Marked up
Drawing 522-004

REVISIONS	
FLORIDA POWER CORPORATION ST PETERSBURG, FLORIDA CRYSTAL RIVER PLANT	
UNIT NO. 3	855 000 KW
AUXILIARY BUILDING SOUTH STEEL FRAMING ROOF AT ELEV 209' 1"	
CRANE RUNWAY STEEL AT ELEV 193' 7"	
DESIGNED BY	GILBERT ASSOCIATES INC
DATE	7/18/20
SCALE	AS SHOWN
PROJECT NO.	4203
REV.	E-522-004
DATE	7/18/20
SCALE	AS SHOWN
PROJECT NO.	4203
REV.	E-522-004
DATE	7/18/20
SCALE	AS SHOWN

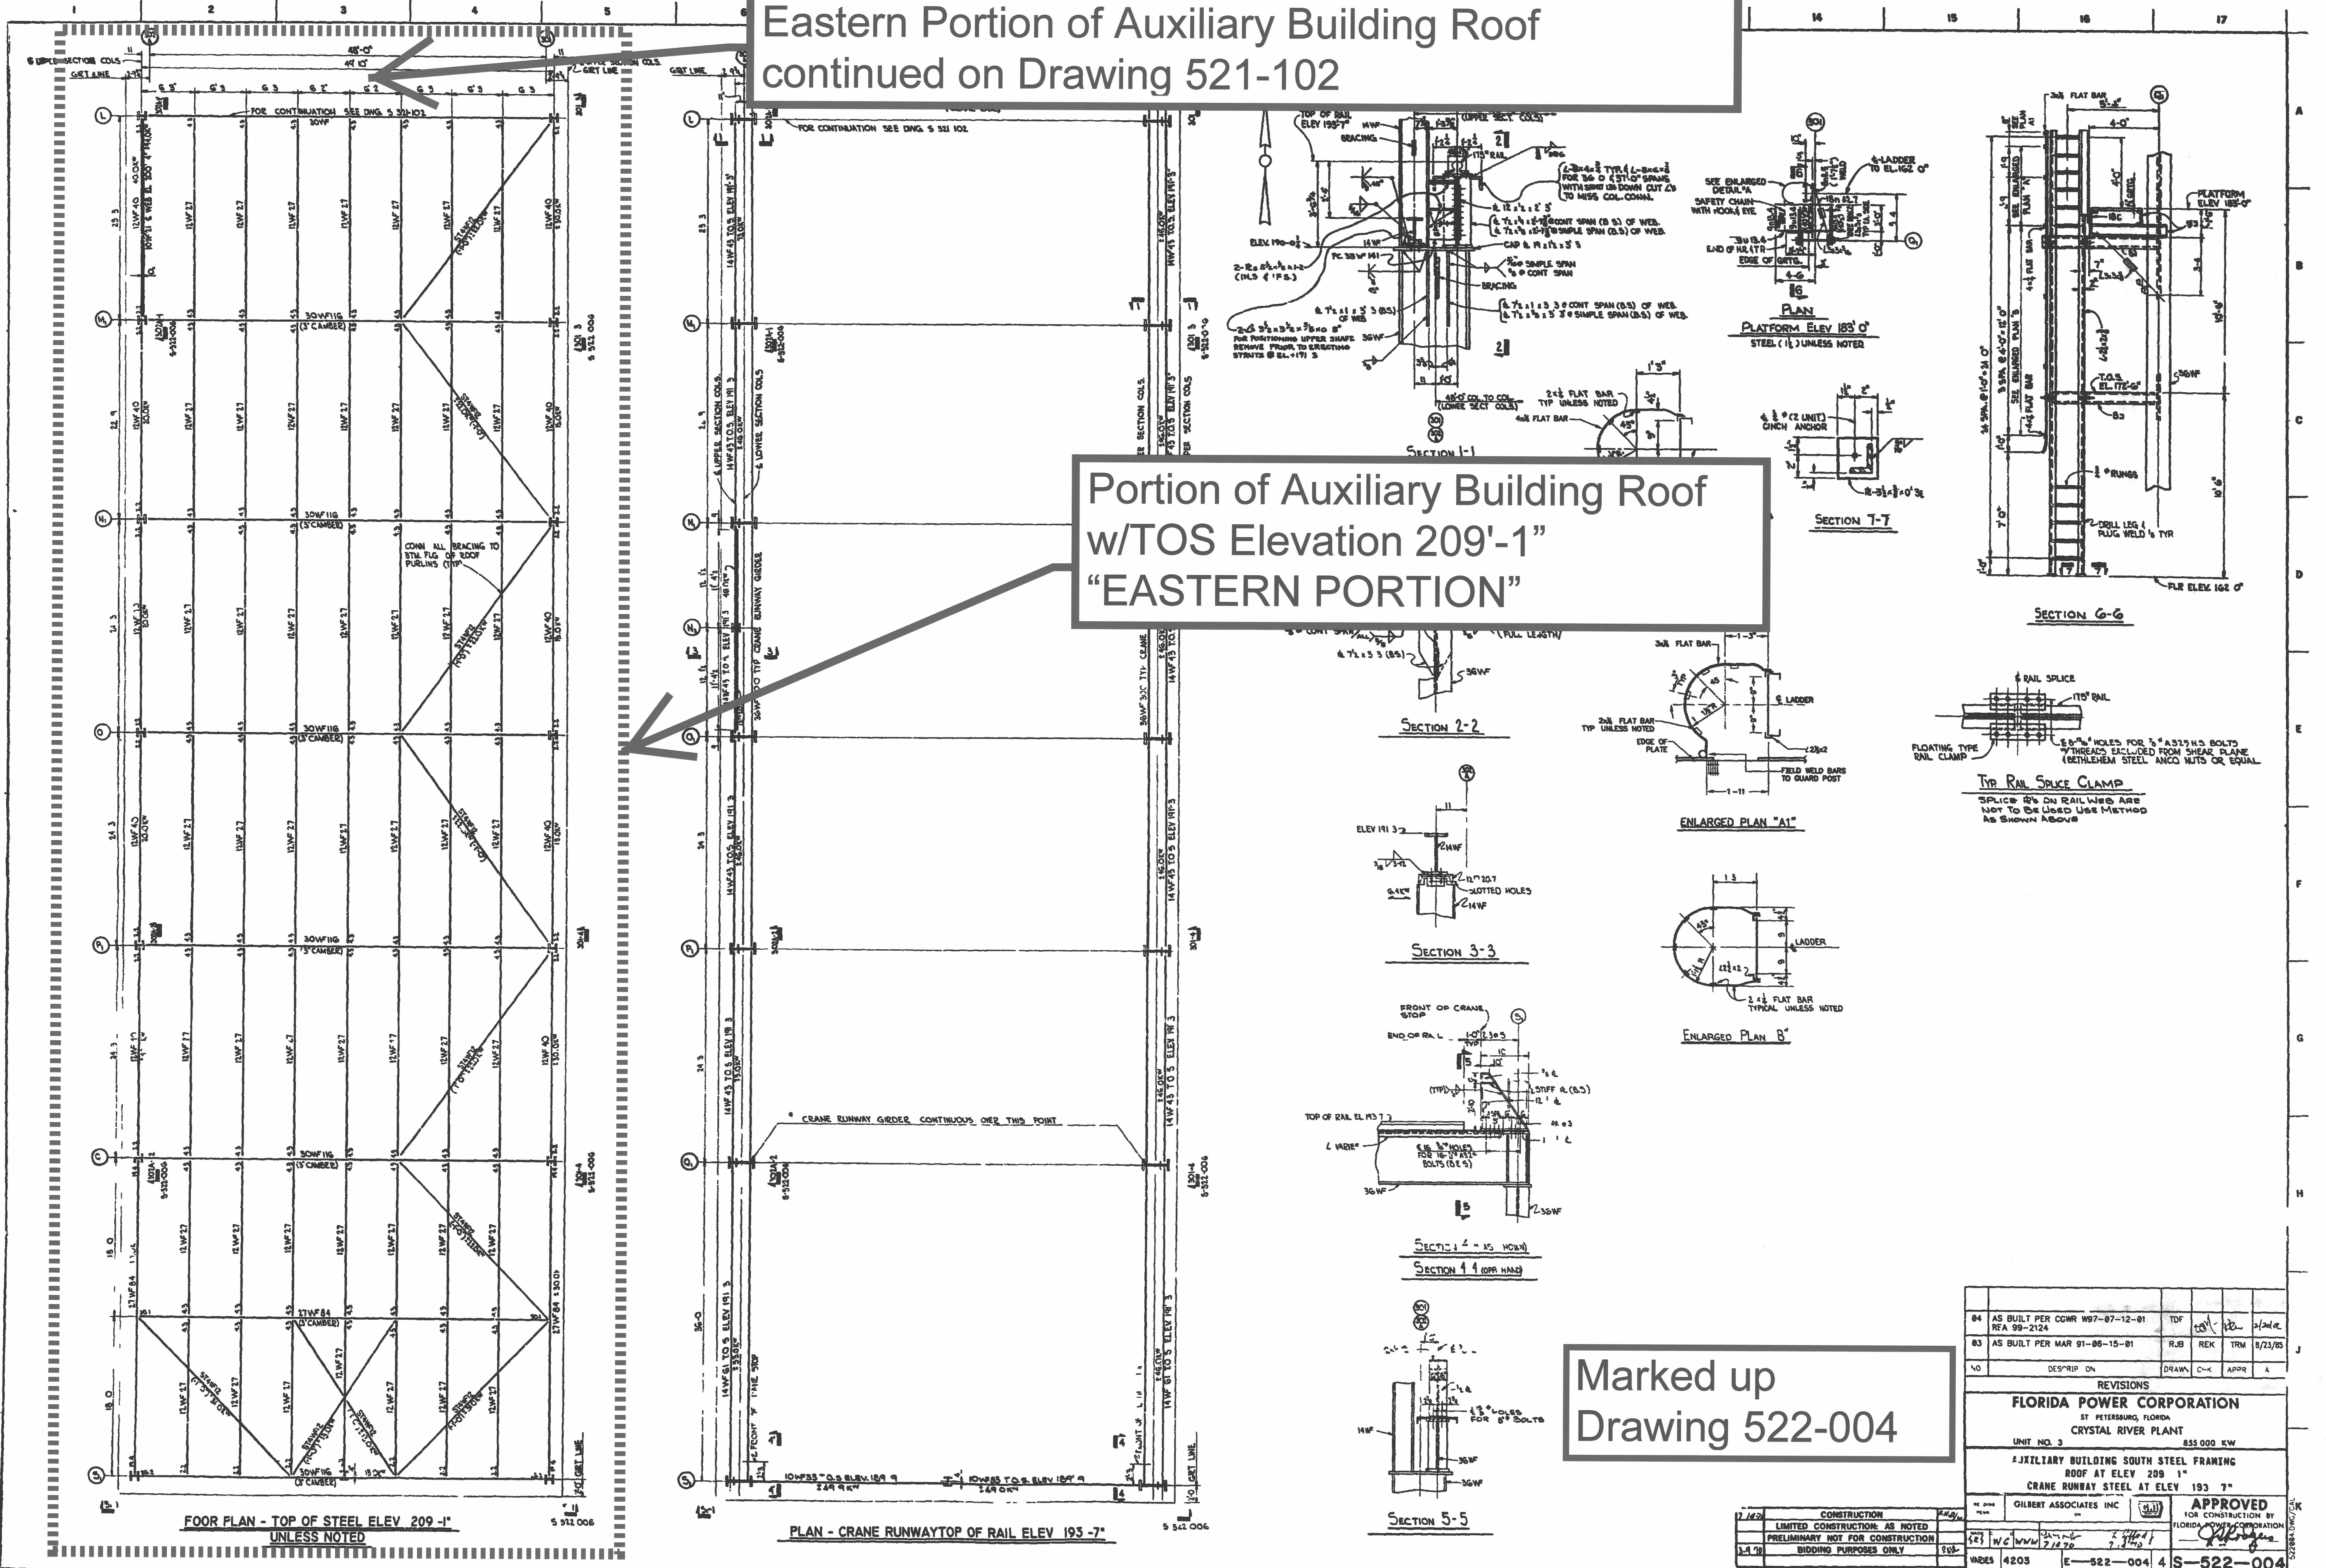
Eastern Portion of Auxiliary Building Roof
continued on Drawing 521-102

Portion of Auxiliary Building Roof
w/TOS Elevation 209'-1"
"EASTERN PORTION"
